**AIA**[®]**Document G704[®] – 2017****Certificate of Substantial Completion****PROJECT:** *(name and address)*
Softball Complex Sulphur Springs Park
Madison County, Mississippi**CONTRACT INFORMATION:**
Contract For: General Construction
Date: 06 May 2024**CERTIFICATE INFORMATION:**
Certificate Number: 001
Date: 11 August 2025**OWNER:** *(name and address)*
Madison County Board of Supervisors
146 W. Center St., Canton, MS**ARCHITECT:** *(name and address)*
JH&H Architects Planners Interiors PA
1047 N. Flowood Dr., Flowood, MS**CONTRACTOR:** *(name and address)*
England Enterprises, Inc.
8295 Wildwood Rd., Vaughan, MS

**SOFTBALL COMPLEX SULPHUR SPRINGS PARK
MADISON COUNTY BOARD OF SUPERVISORS
21-027B**

MECHANICAL SYSTEM PROJECT OBSERVATION SUBSTANTIAL COMPLETION

Schultz & Wynne Job Observation Report

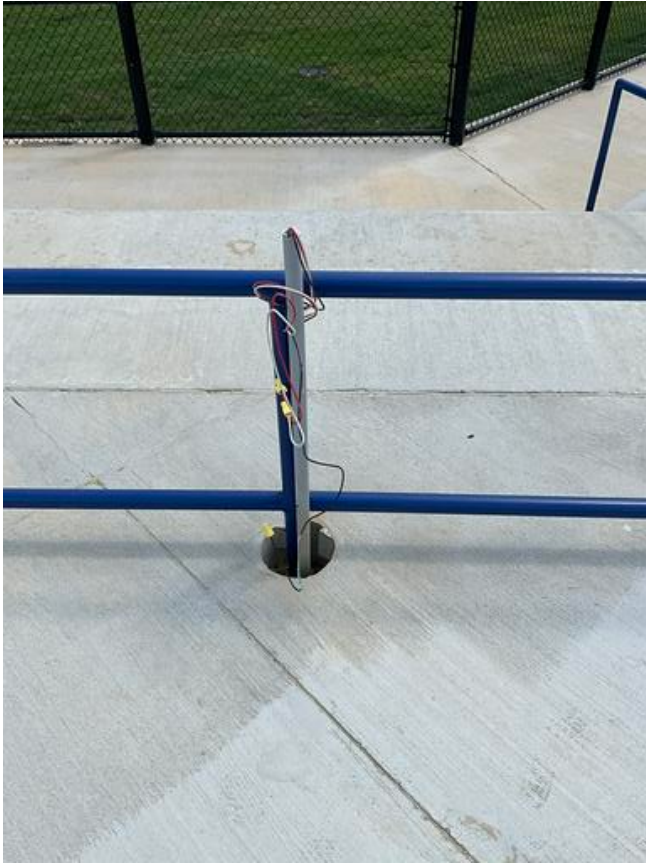
6. Mini split power whip is required to be LFMC.

7. Mini split power whip requires fittings to be steel.

8. Mini split power whip needs to be strapped to wall.
